CITY of NOVI CITY COUNCIL June 2, 2025

SUBJECT: Consideration of a Special Land Use and Preliminary Site Plan approval for Dick's

House of Sport

Dick's Sporting Goods JSP24-31 March 14, 2025

DRAWING NO.

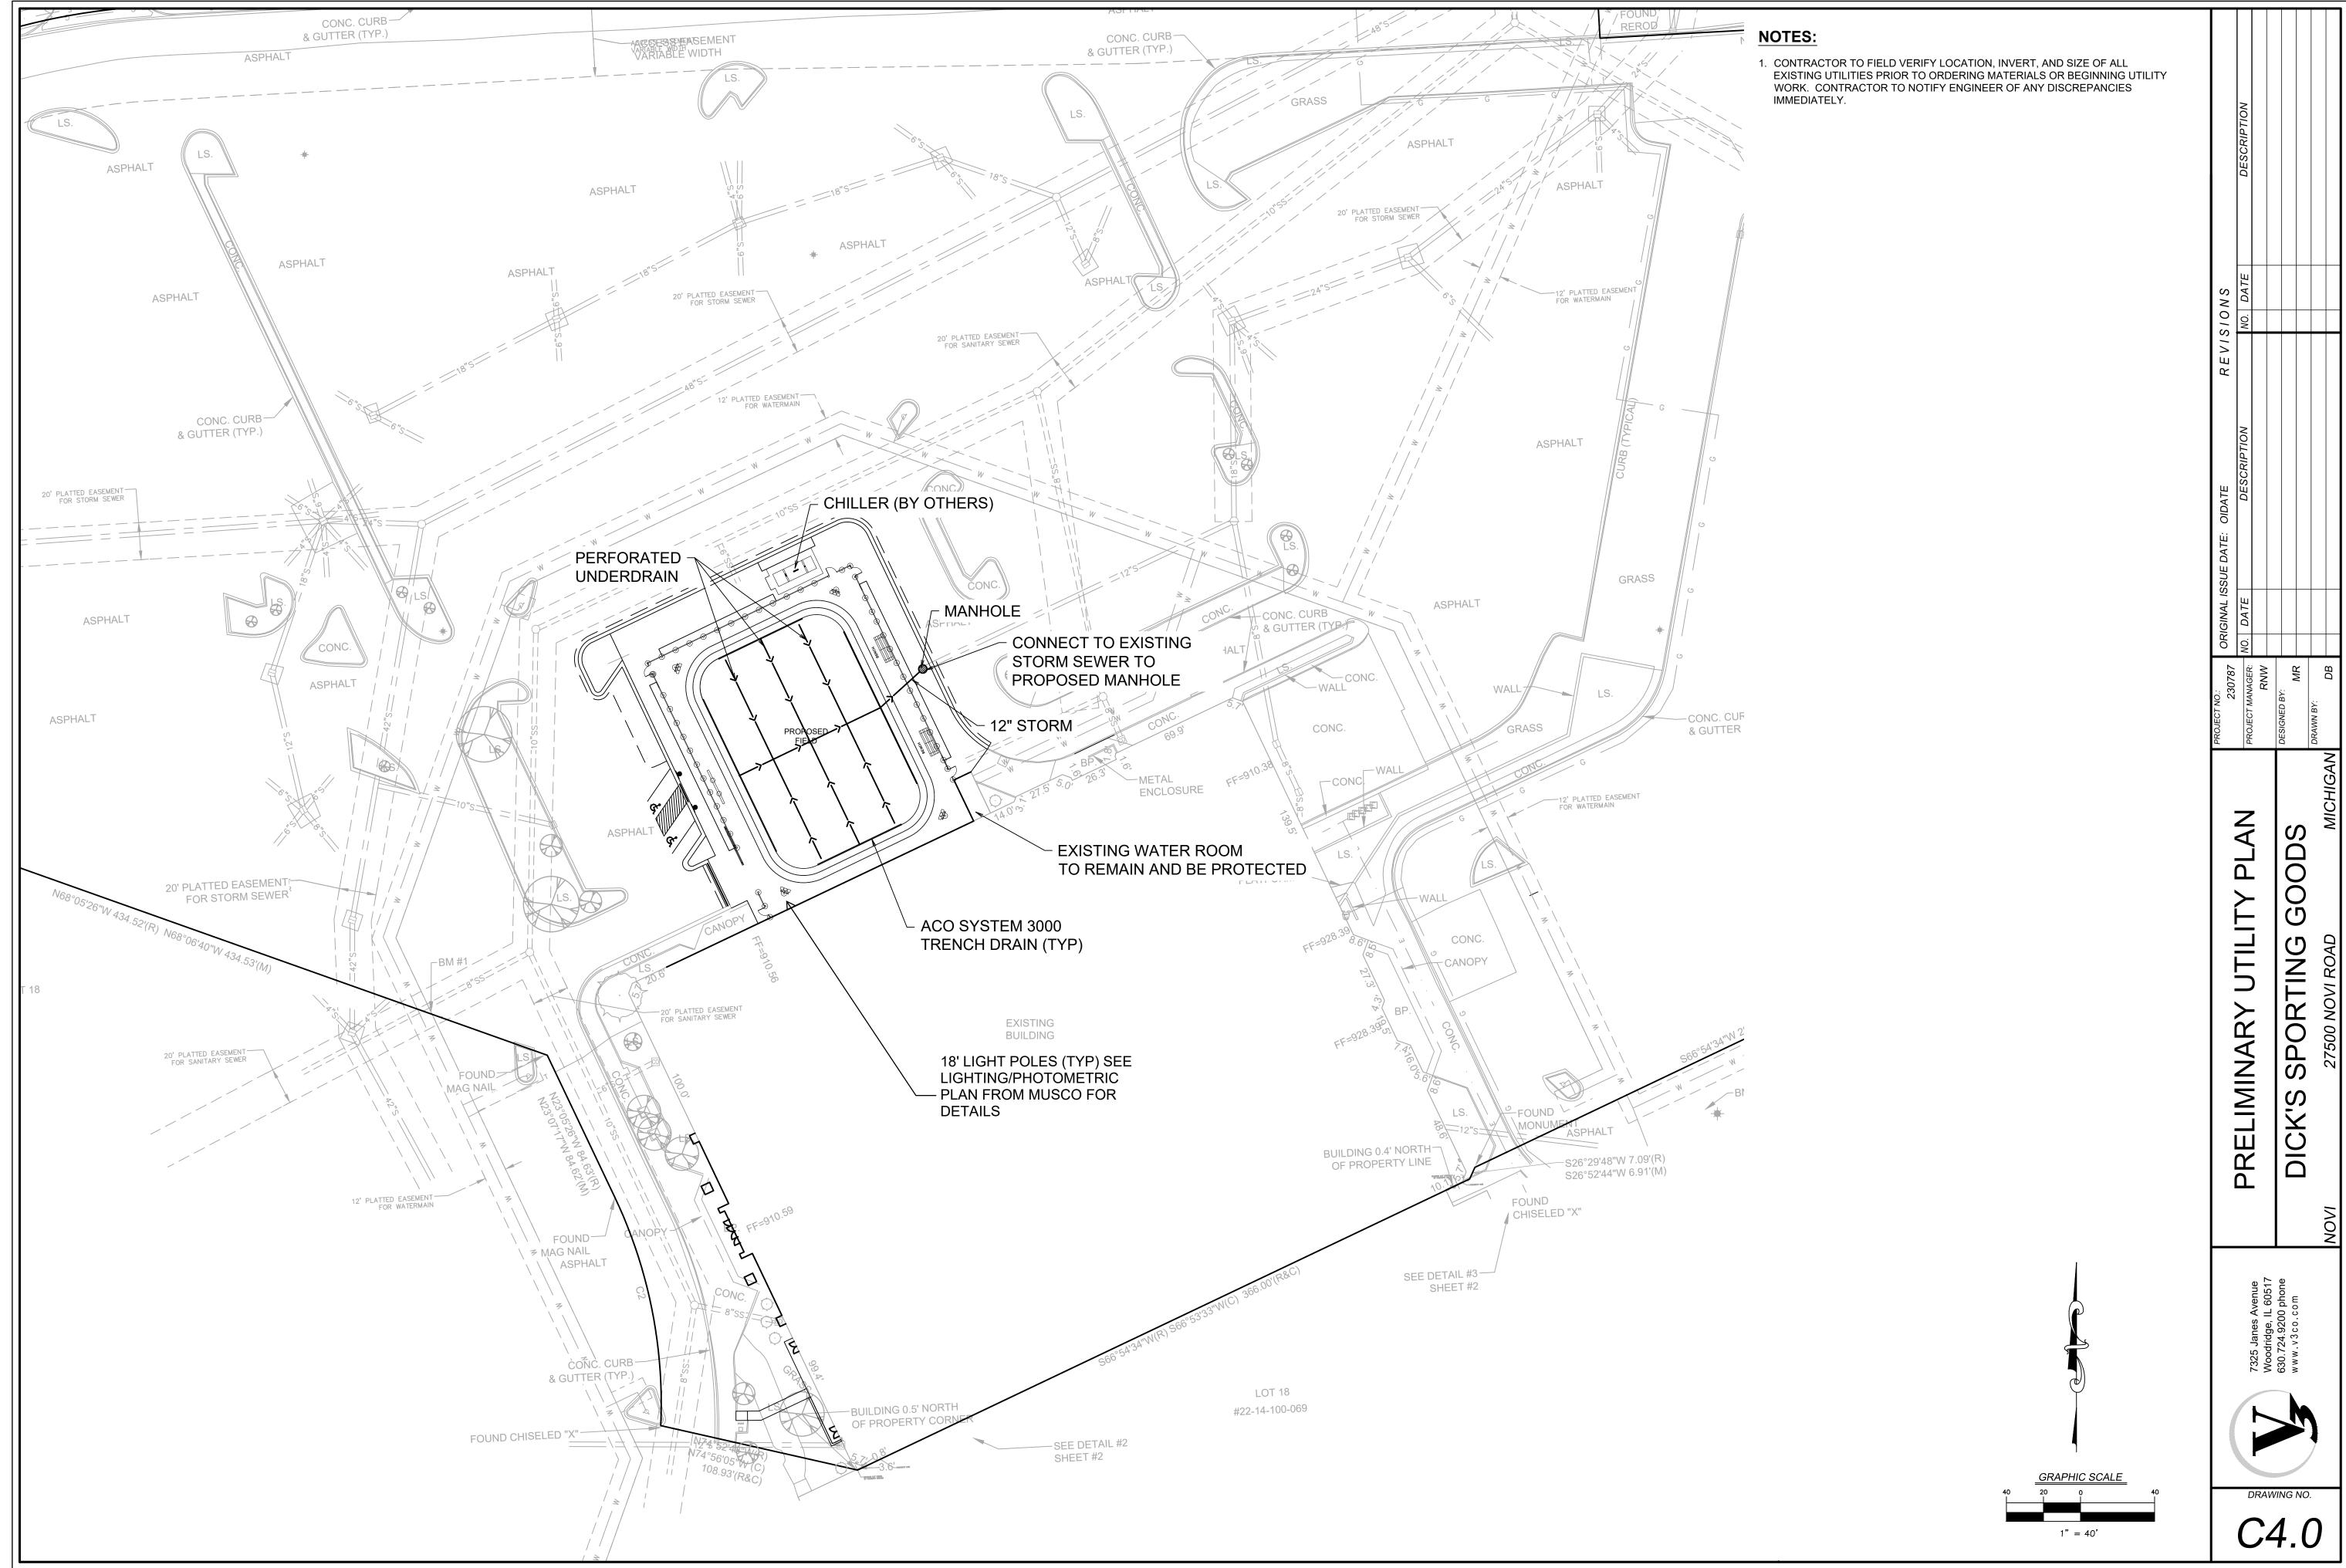
Comment 15: Sheet C4.0 indicates 18' light poles, lighting specifications and response letter indicate
